Product / Process Change Notification (PCN)

PCN #: PCN_UtCST_20200805

Affected Series: WE-CST; 749251xxx

Before Change:

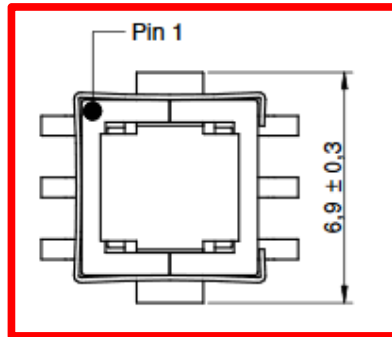
Because of a database mismatch, Würth Elektronik will change the location of the pin 1 dot on its datasheet as well. The pin 1 dot will be moved from the core to the clip.

The pin 1 dot was previously located on the core of the product (shown below in red) and will be moved to the clip (shown below in green).
